Intel[®] 82579 GbE PHY Specification Update

October 2012
v2.5

Reference Number: 324967-005

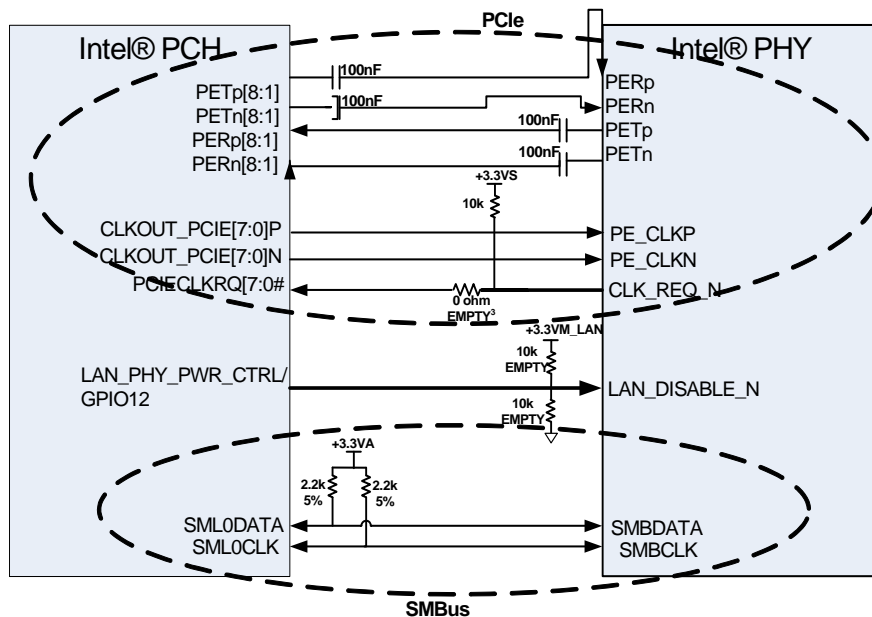
3. Document: Intel® 82579 Gigabit Ethernet PHY v2.1: Text Change.

Change: Chapter 2, Figure 2 Intel 6 Series Express Chipset/82579 Interconnects; Chapter 16, Figure 16-9; and Chapter 17, Figure 17-9 should appear as follows:
